COMMONWEALTH of VIRGINIA

DEPARTMENT OF TRANSPORTATION
1401 EAST BROAD STREET
RICHMOND, VIRGINIA 23219-2000

July 21, 2004

MEMORANDUM

STANDARD ENDWALL FOR PIPE UNDERDRAIN

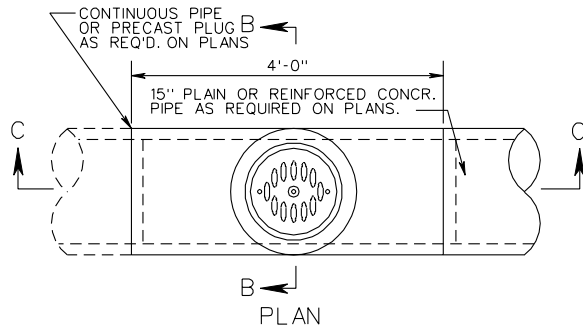
PAGE	INSERT	STANDARD	REVISION
101.32	A57	EW-12	Revised note.
104.25	A158	DI-9	Revised riser pipe dimension.
107.02	A86	PB-1	Revised transposed dimensions For S1 and S2 on normal earth foundation no projection.
109.01	ISD570	PG-2A	Revised concrete surface area for TY A1 D=8" from .0759 to 0.0759.

STANDARD SOLID CONCRETE RAISED MEDIAN STRIP

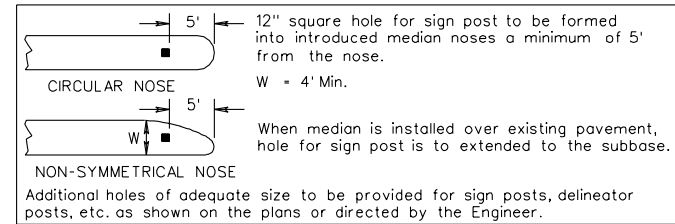
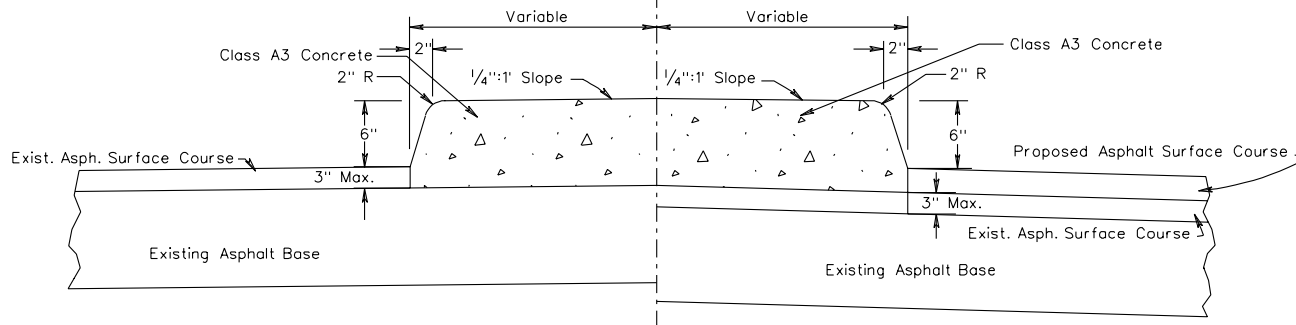
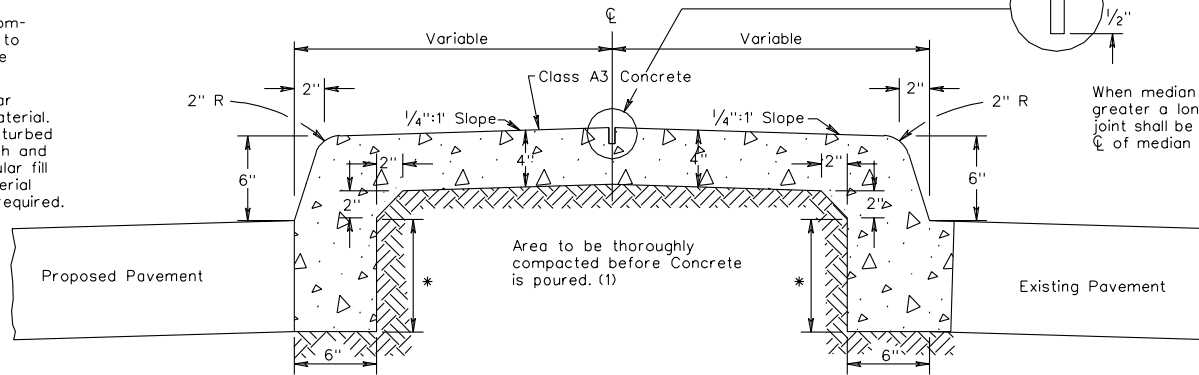
PAGE	INSERT	STANDARD	REVISION
115.01	ISD414.04	ESC-INS	Revised ditch reference notes.
202.02	A159	MS-1	Revised minimum width.
202.03	A159	MS-1A	Revised minimum width.

CG-12 DETECTABLE WARNING SURFACE
TYPE C (PARALLEL & PERPENDICULAR) APPLICATION

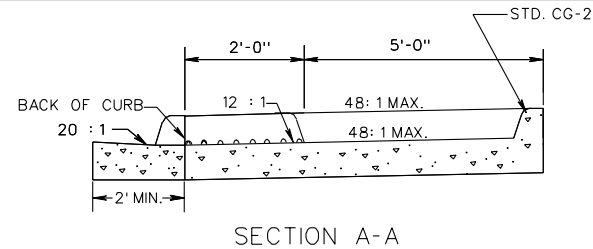
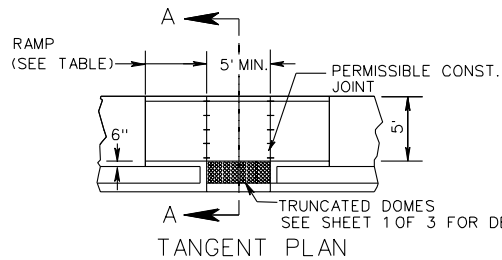
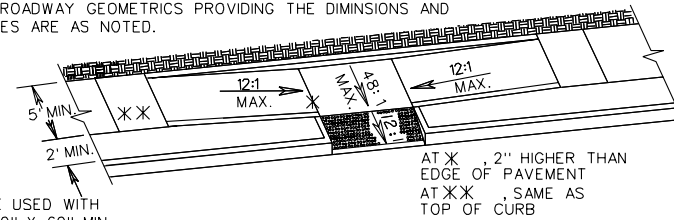
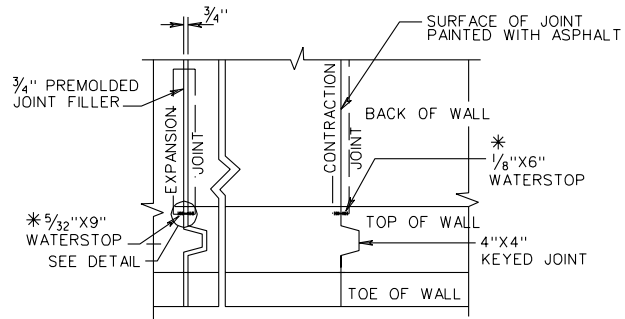
203.06	A59	CG-12	Added ramp length table.
203.07	A59	CG-12	Added ramp length table.
401.02	A161	RW-3	Revised annotation of porous backfill.
501.06	A133	GR-3	Revised notes.

TERMINAL TREATMENT FOR W BEAM GUARDRAIL

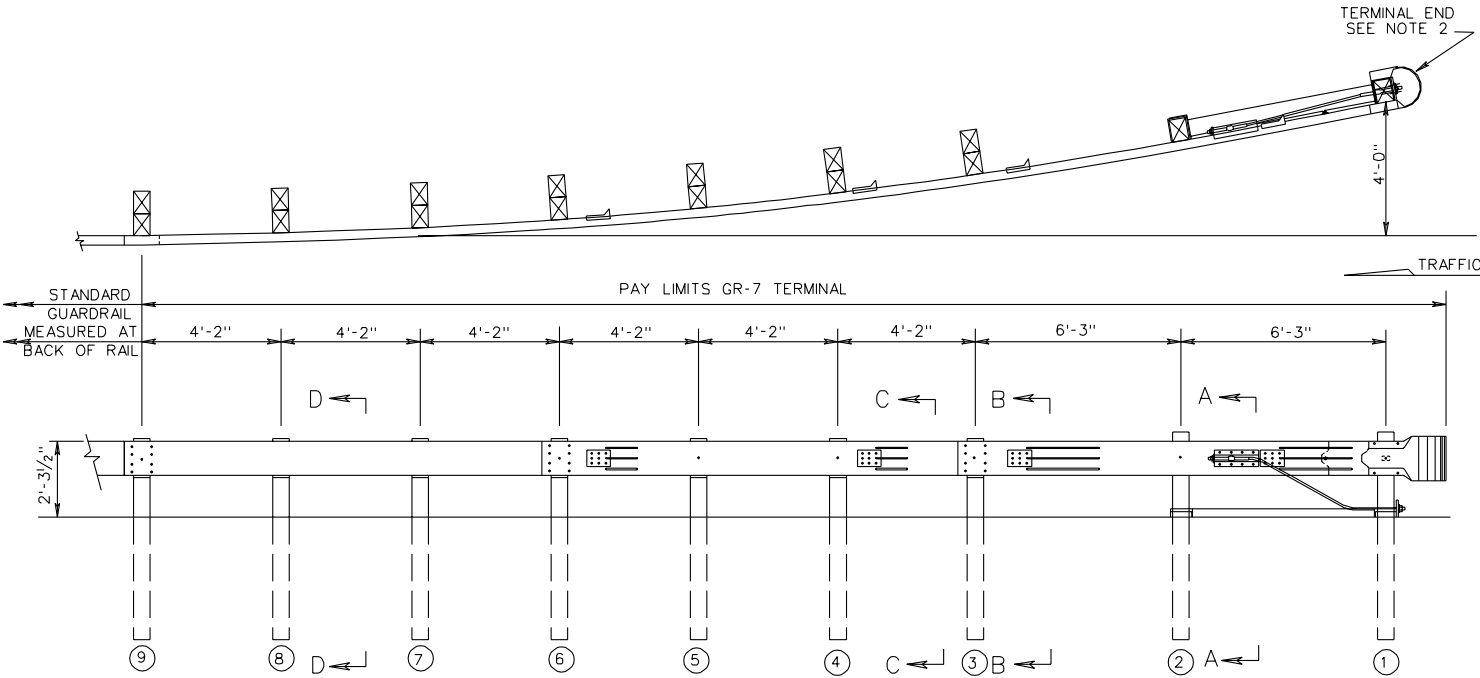
501.08	A133	GR-3	Clarified anchor dimensions, revised notes.
501.10	A132	GR-6	Revised rail length in detail A.
501.11	A89	GR-7	Revised notes and clarified details.

BREAKAWAY CABLE TERMINAL 4' FLARE

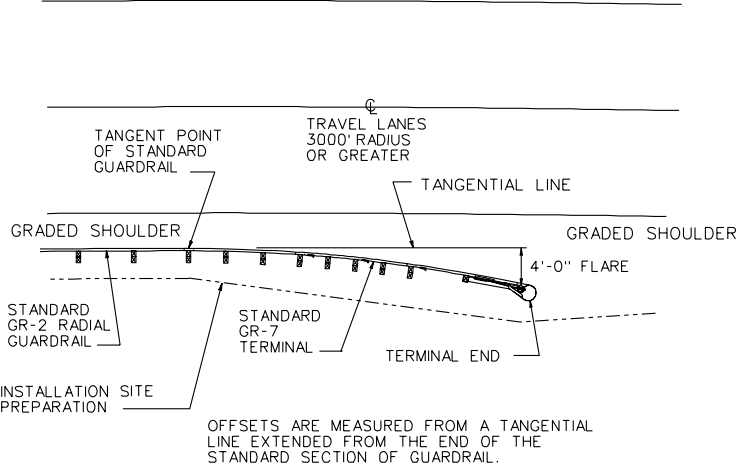
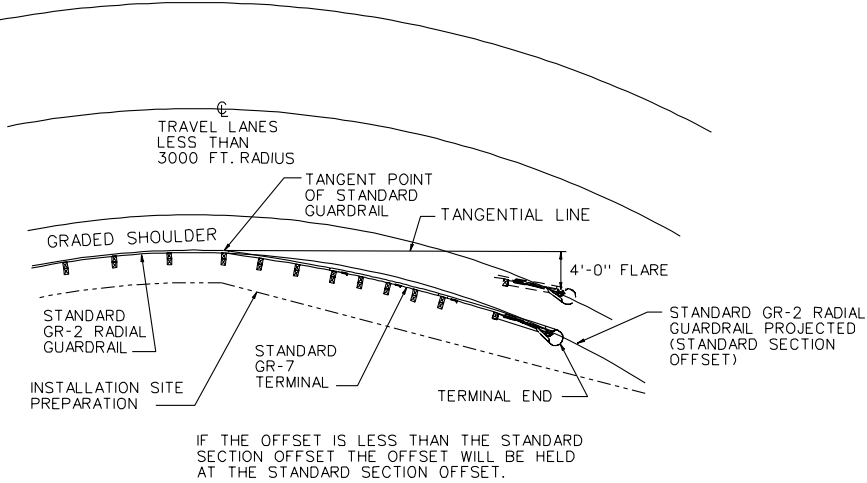
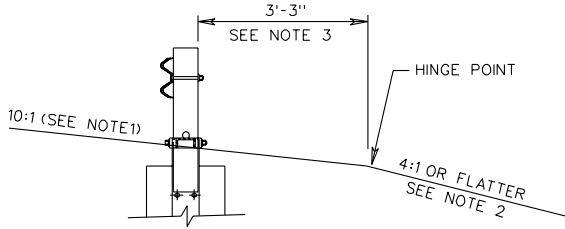
501.12	A89	GR-7	Deleted page.
501.13	A89	GR-7	Chaged sheet reference.
501.16	A136	GR-SP	Revised notes.
501.18	ISD2390	GR-9	Revised notes and clarified details.

TRANSITION FROM 50" TALL WALL TO 32" JERSEY OR F-SHAPE BARRIER

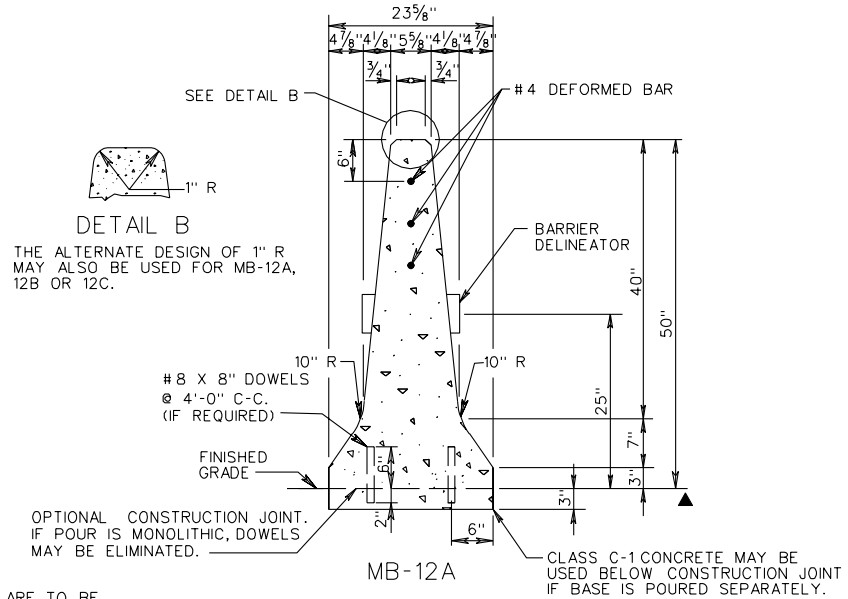
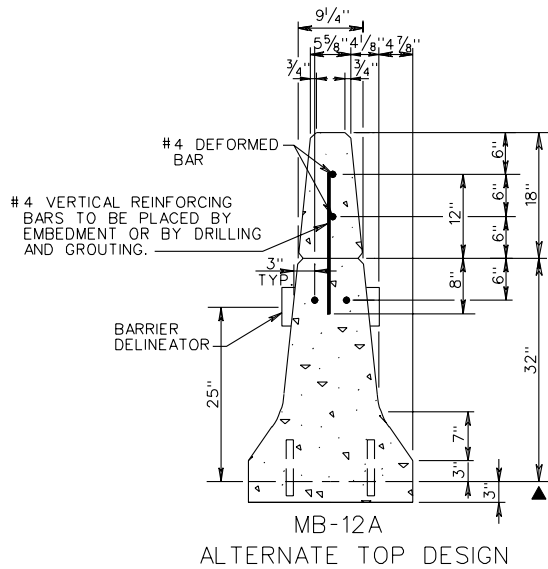
501.55	A96	MB-12A,B,C	Revised references to barrier shapes for transition details.
502.02	A160	FE-W1,W2	Added brace dimensions.
502.03	A160	FE-B	Added brace dimensions.

STANDARD FENCE
CHAIN LINK

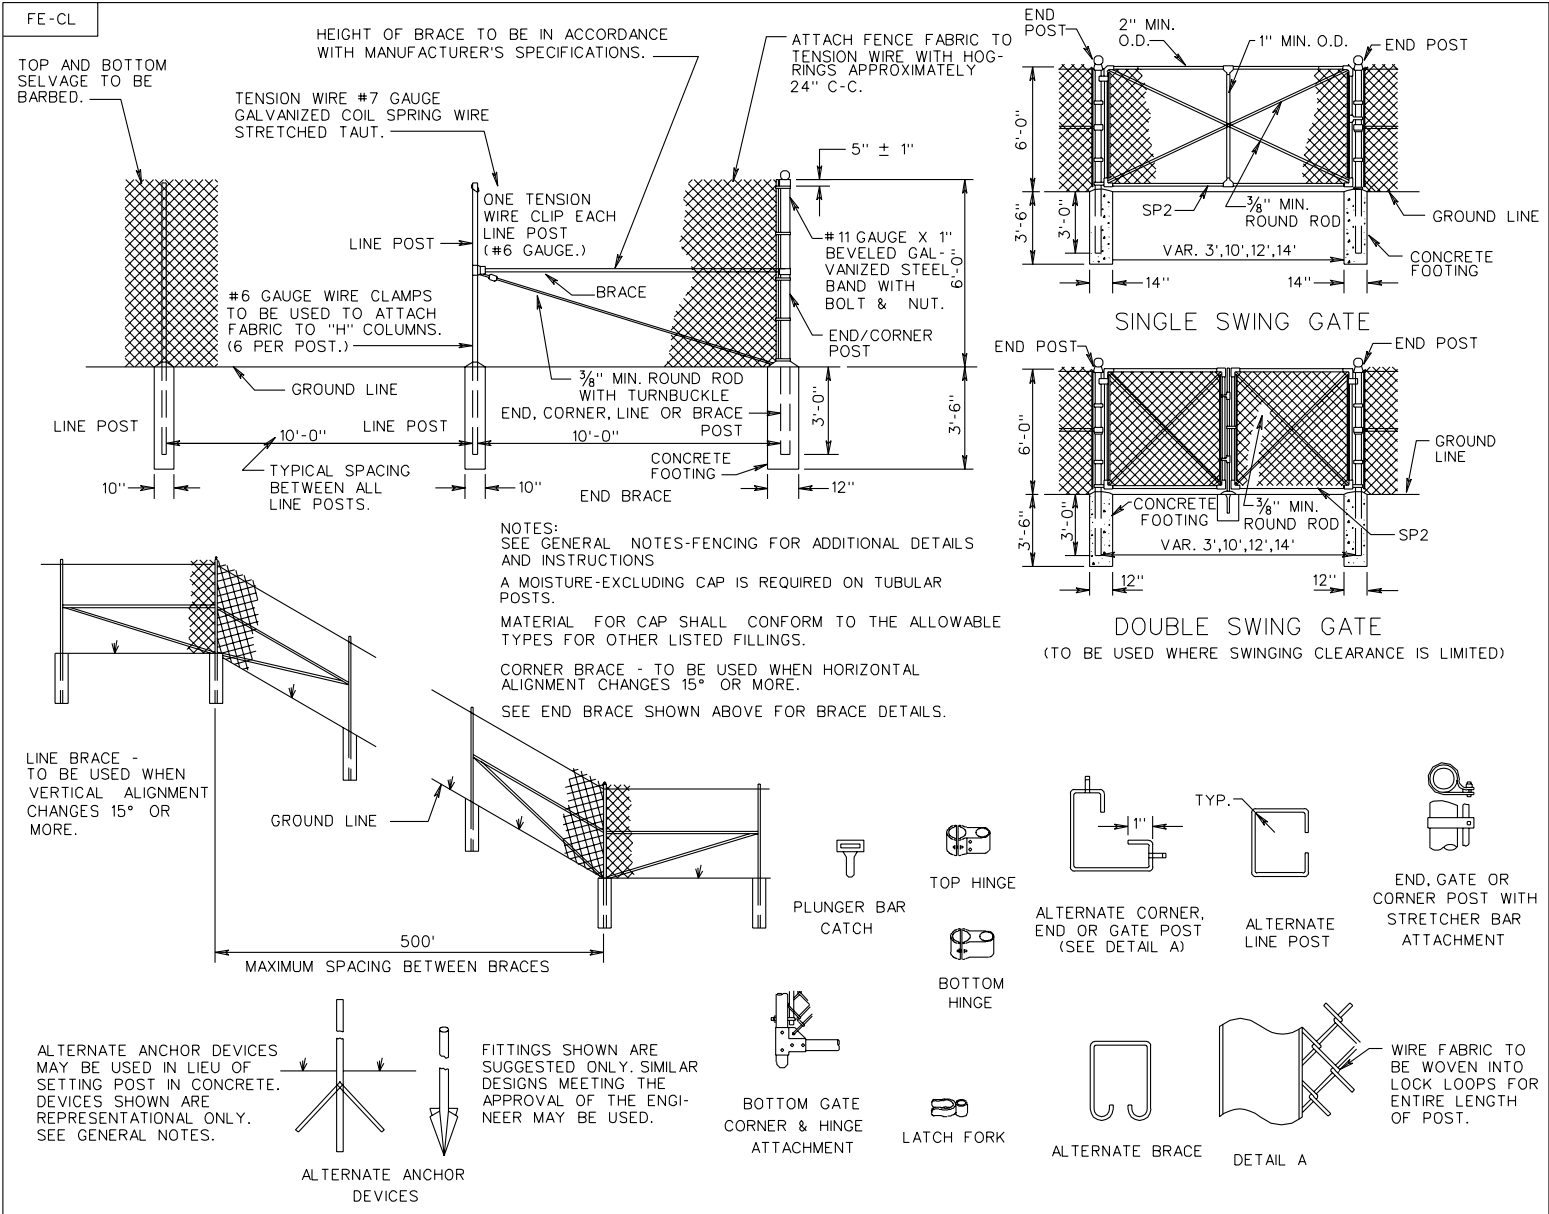
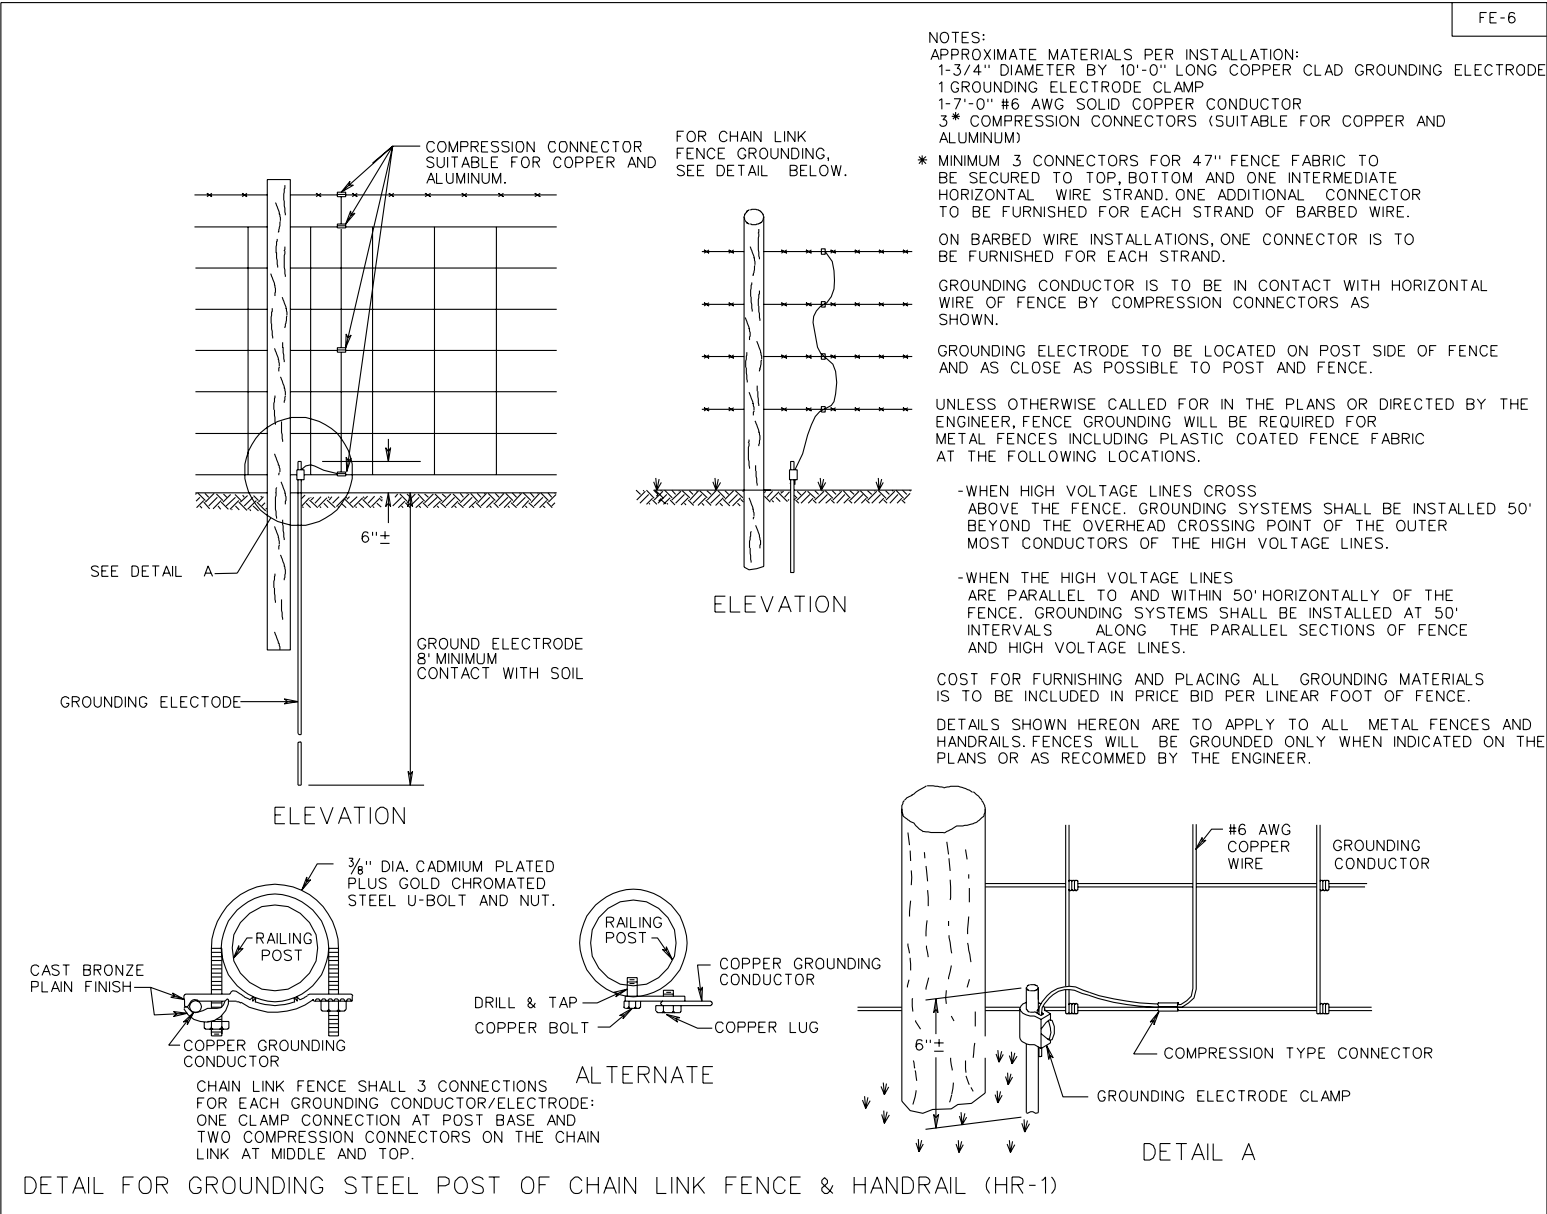
502.04	A152	FE-CL	Revised references to federal specification for post designations.

SPECIFICATION REFERENCE	STANDARD METHOD OF FENCE & HANDRAIL GROUNDING	
507 238	VIRGINIA DEPARTMENT OF TRANSPORTATION	REV 7/04 502.07

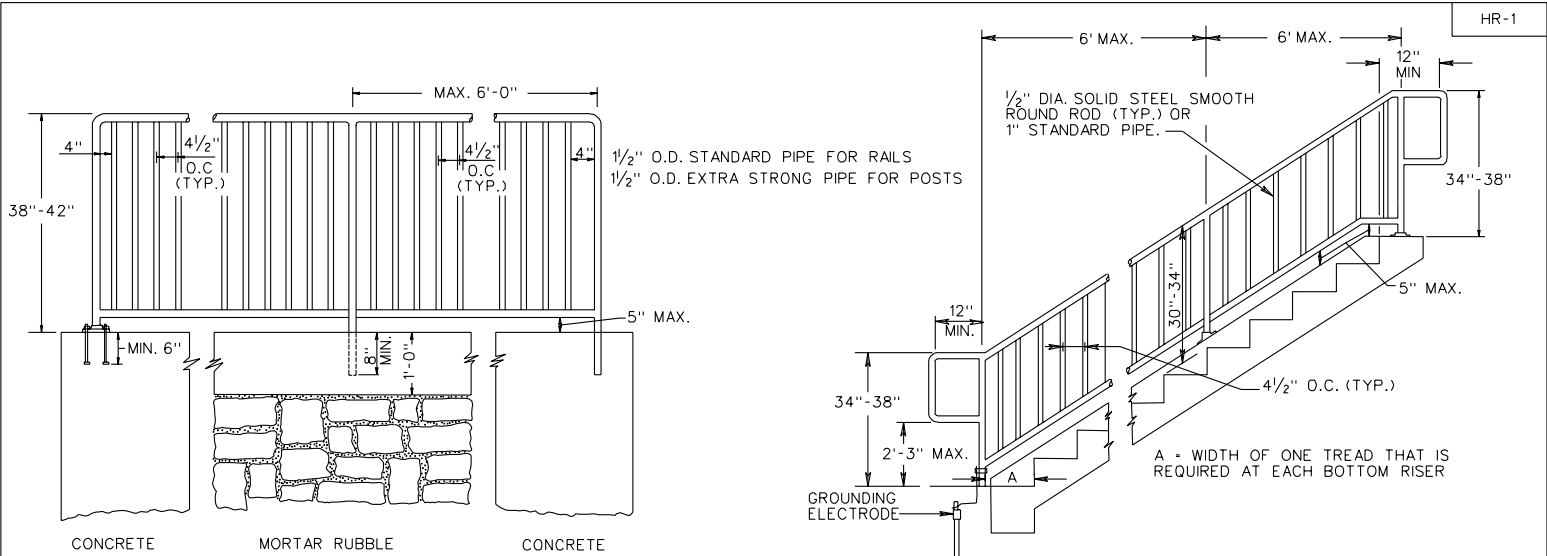
PAGE	INSERT	STANDARD	REVISION
502.07	A152	FE-6	Revised notes. Revised grounding details.
601.05	A68	HR-1	Revised handrail height, added grounding details.
